ADDENDUM 5

DATE: 05/25/22

'Matilda Torres High School, Toros Stadium'
Matilda Torres High School
16645 Road 26. Madera, CA 93638

DARDEN PROJECT NO. 0622.4
DSA File Nos. 10-C3
DSA APPL. NO. 02-118396

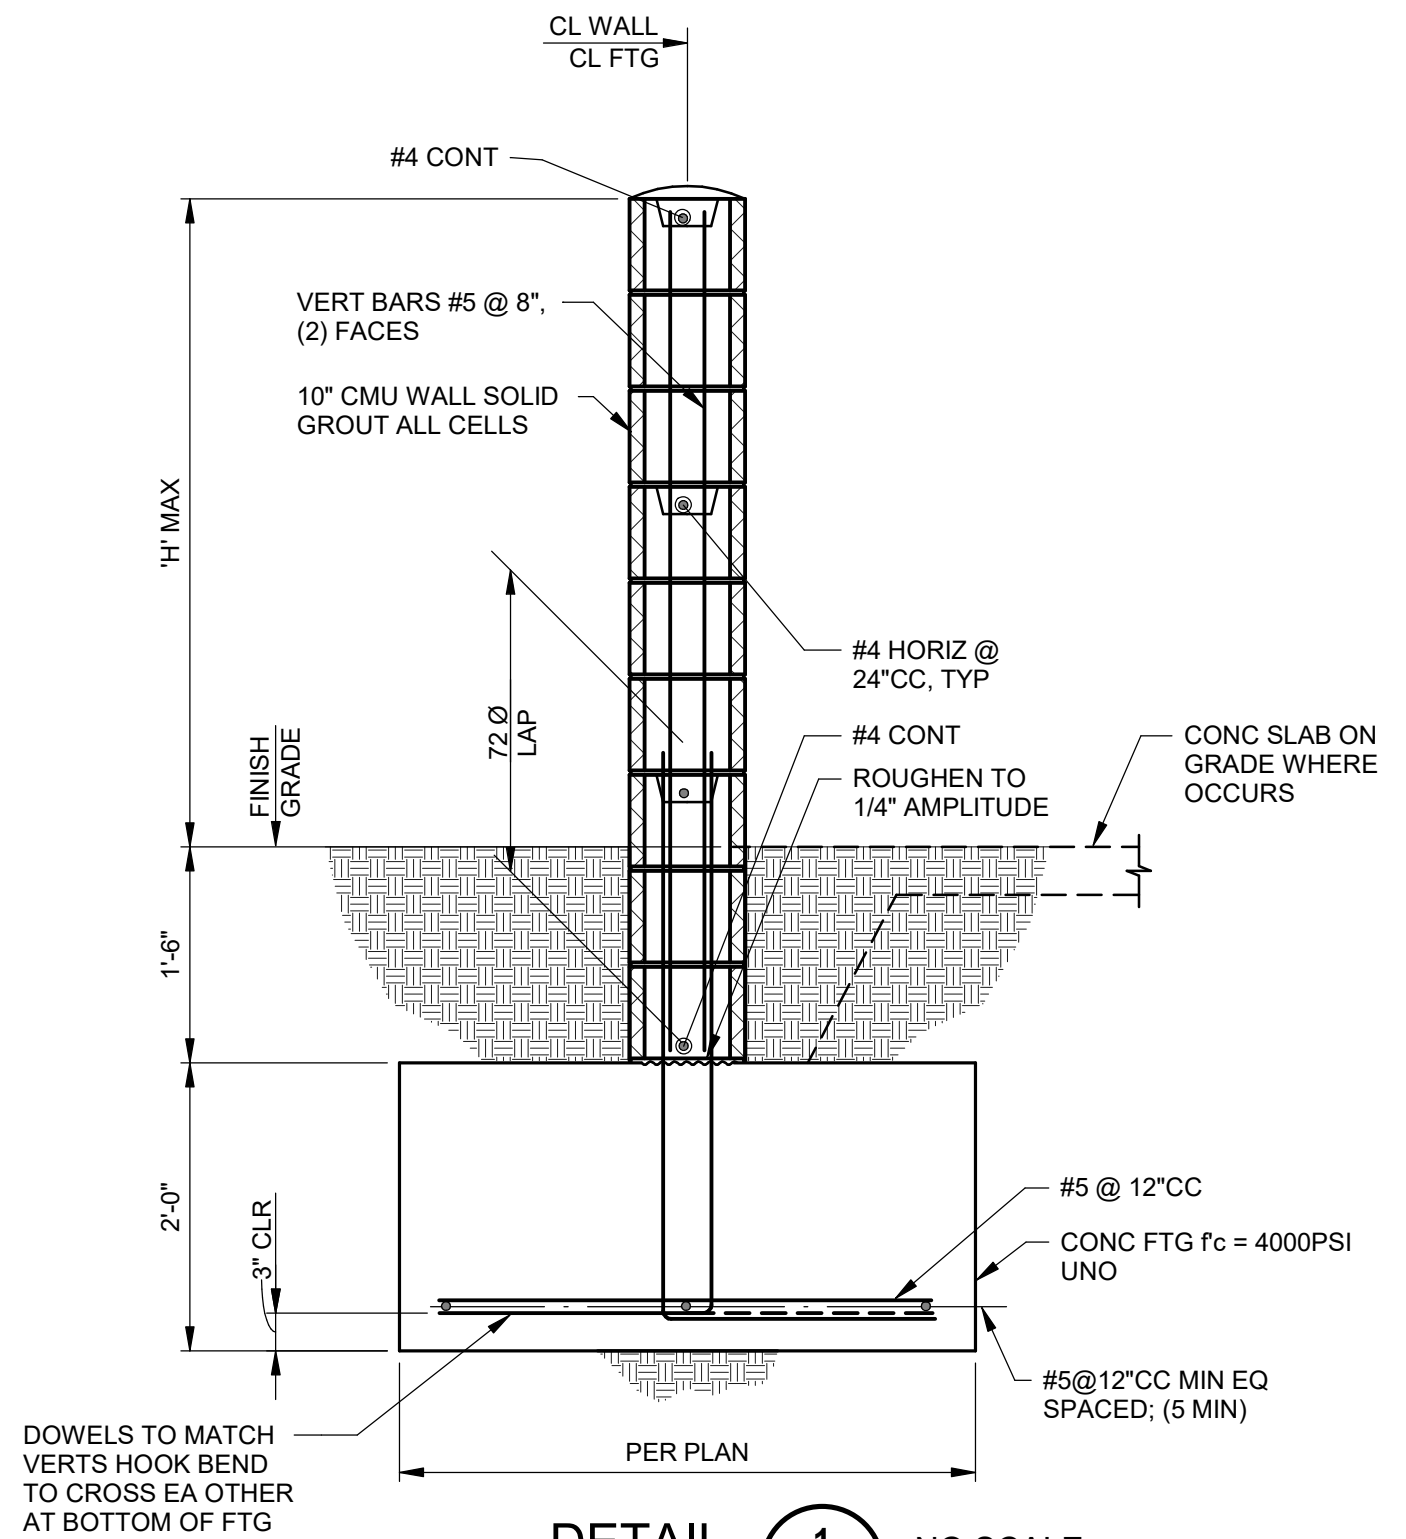
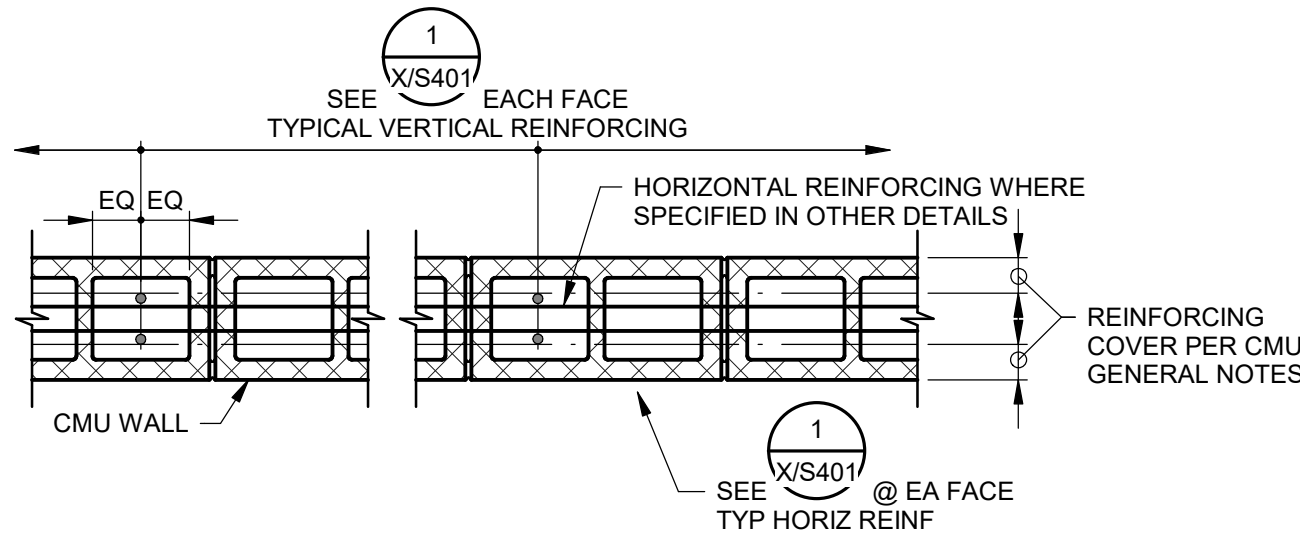
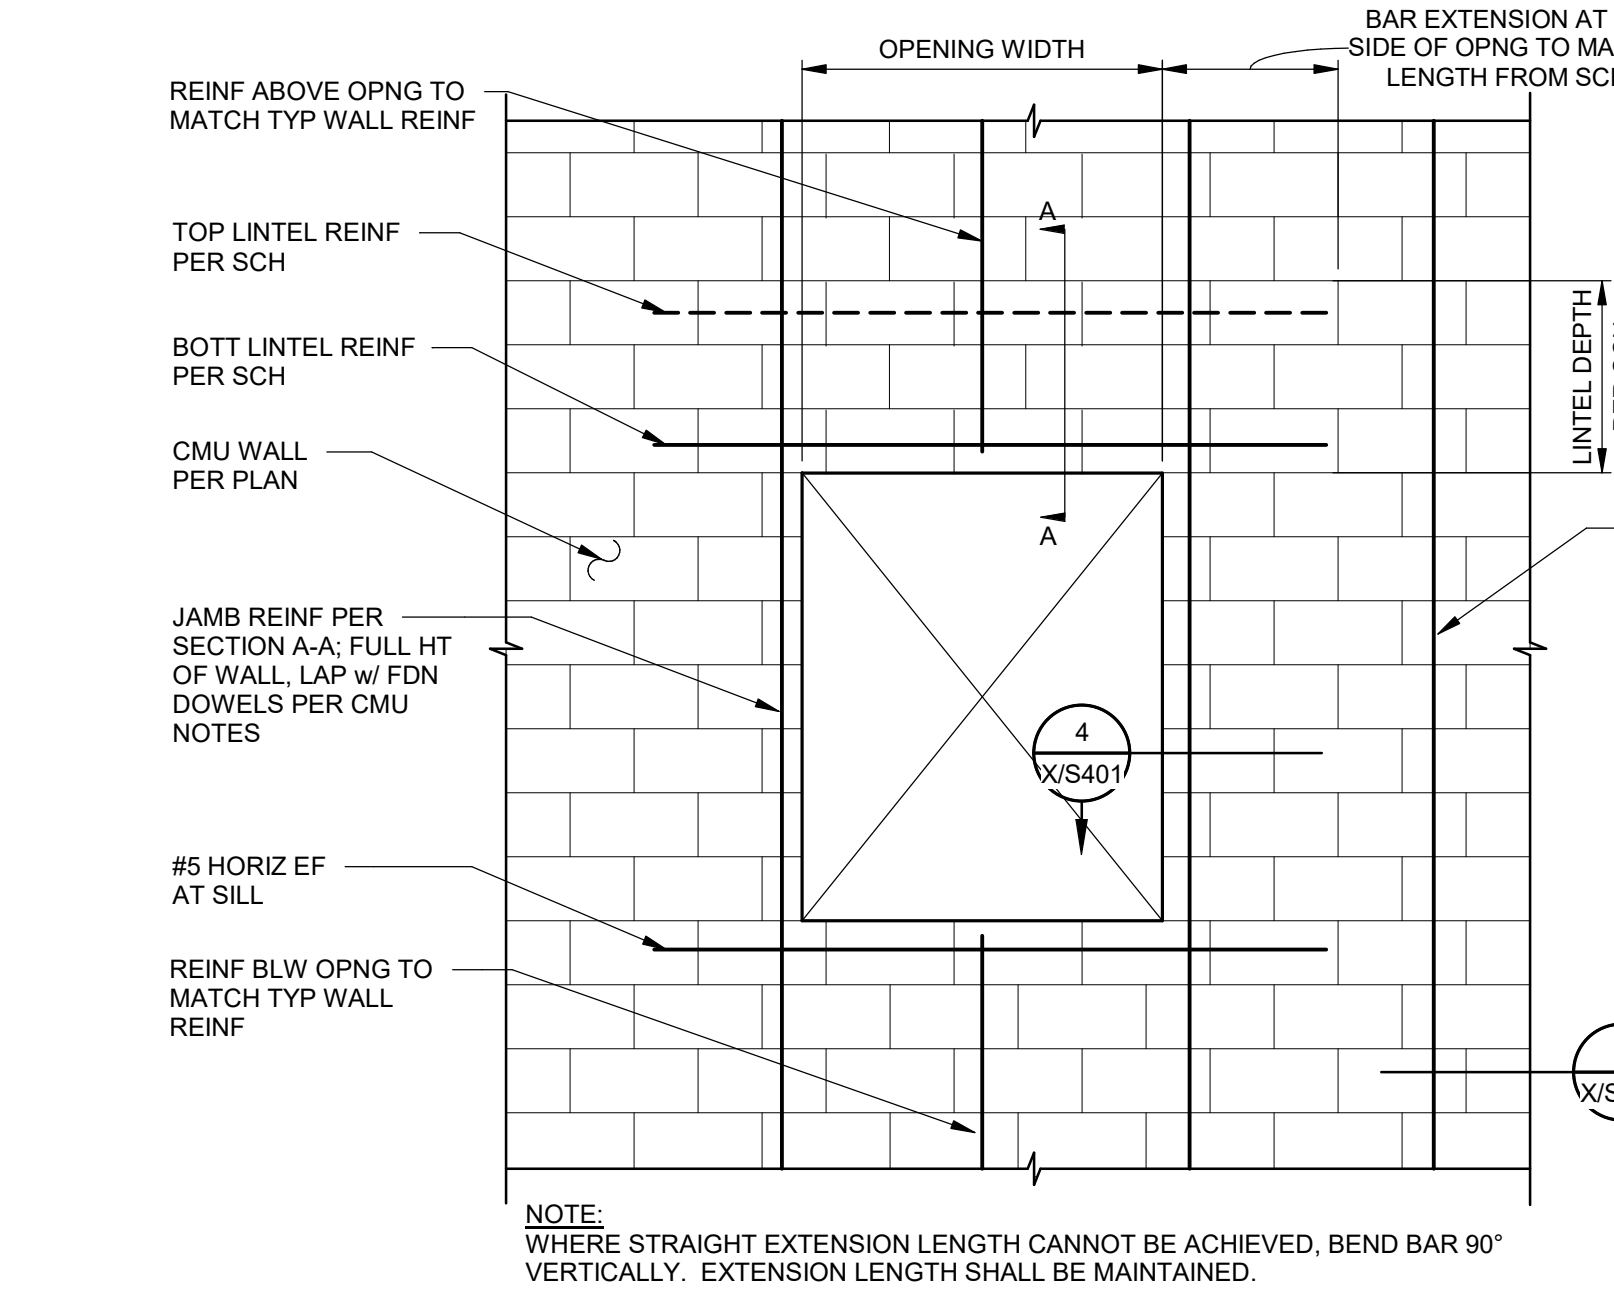
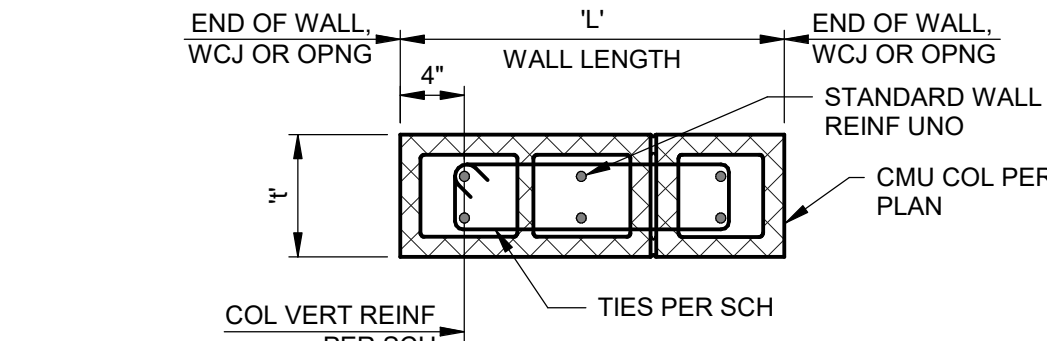
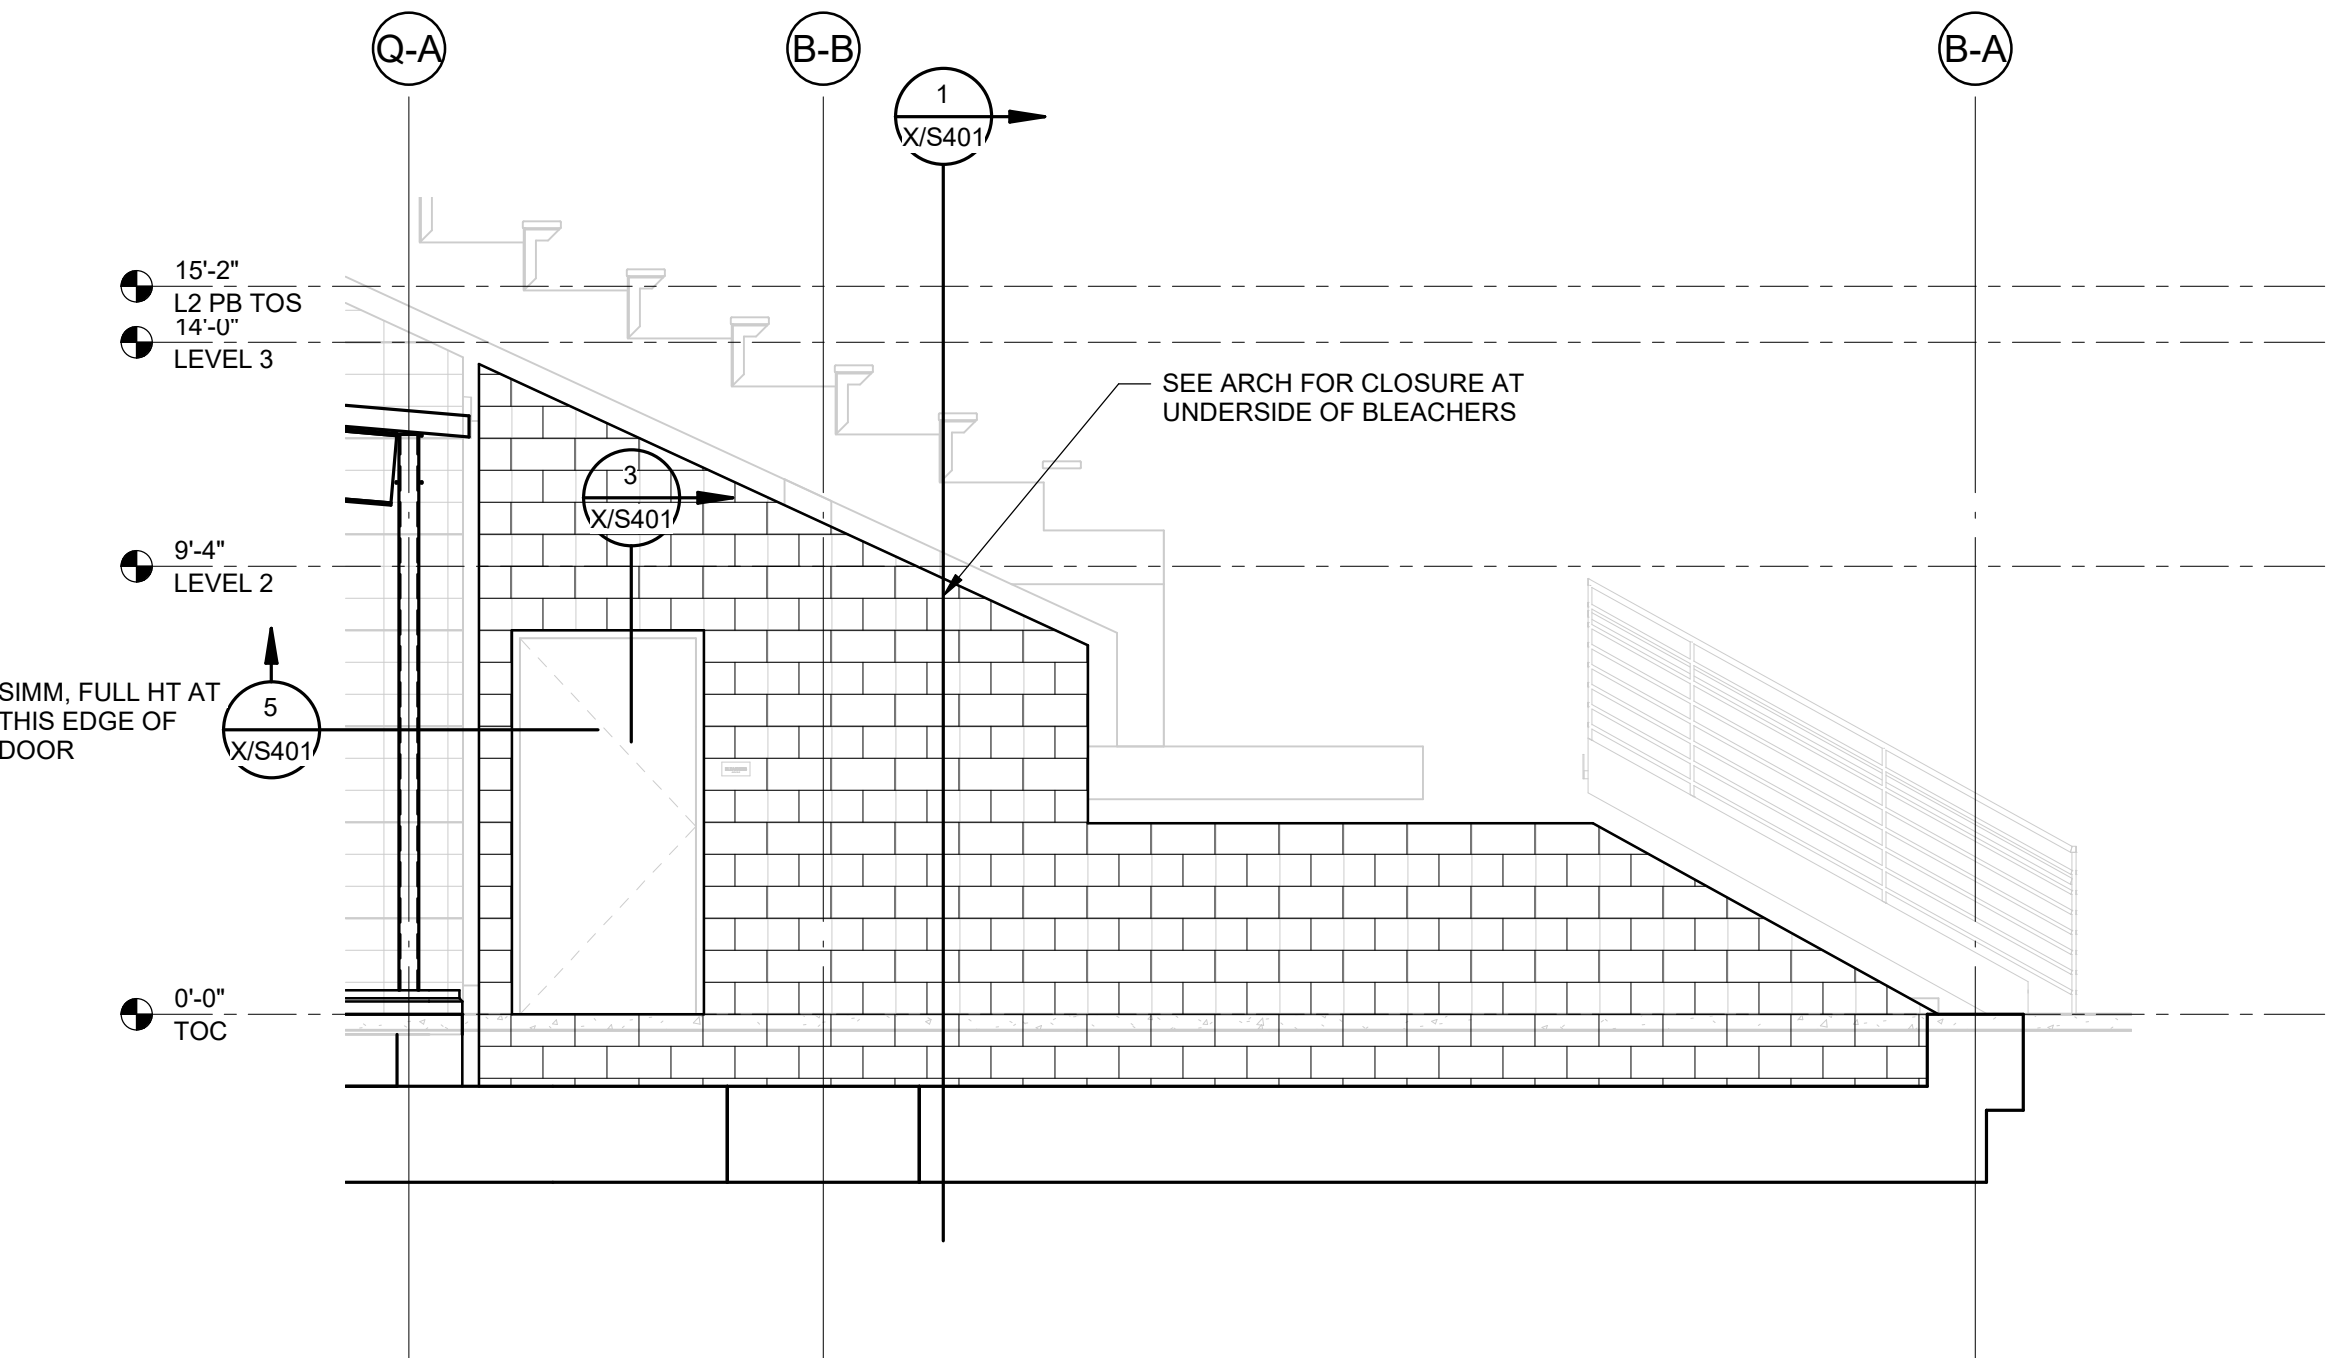
AD5-S04 Refer to G000 Title Sheet

1. Insert attached sheet AD5-SX04 as "X/S401 CMU DETAILS "
 - a. structural requirements and details for CMU walls added
